Project: IEEE P802.15 Working Group for Wireless Personal Area Networks (WPANs)

Submission Title: comment and resolution about CID 64 and etc.

Abstract: Collect PHY Header related comment to resolve together

Purpose: Contribution to IEEE 802.15.7 TG-VLC

❖ IEEE 802.15.4

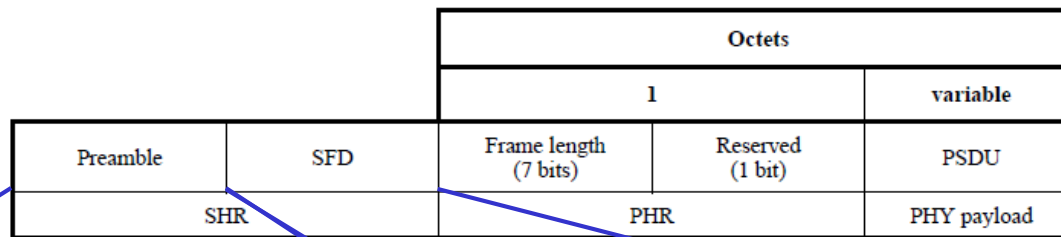
- (TR) §7.4.2, p. 163, l. 40–44: The phrase “where 6 represents ...” seems to be a remnant of the corresponding clause of the IEEE 802.15.4–2006 specification (where the PPDU has size 6 octets, viz. preamble: 4 octets; SHR: 1 octet; length: 1 octet). With 802.15v1c, the PHY header has variable size and contains more octets than with 802.15.4–2006. Suggested remedy: Correct the formula accordingly.

- Correct the formula accordingly.

New calculation CID 722

$$\text{AckWaitTime} = \text{backoff period} + \text{turnaround time} + \text{clock period} * \text{numSymAckFrame}$$

- Where numSymAckFrame is the number of bits in the acknowledgement frame. numSymAckFrame = 12.875*8 for PHY I & II and 13.875*8 for PHY III. For B-ACK mode, the AckWaitTime would be larger, depending on the number of acknowledgements in the b-ack mode as explained in 7.2.2.2. The clock period is obtained via the optical rates specified in Tables 2 and 3.

- Replace formula with above equation and supporting text
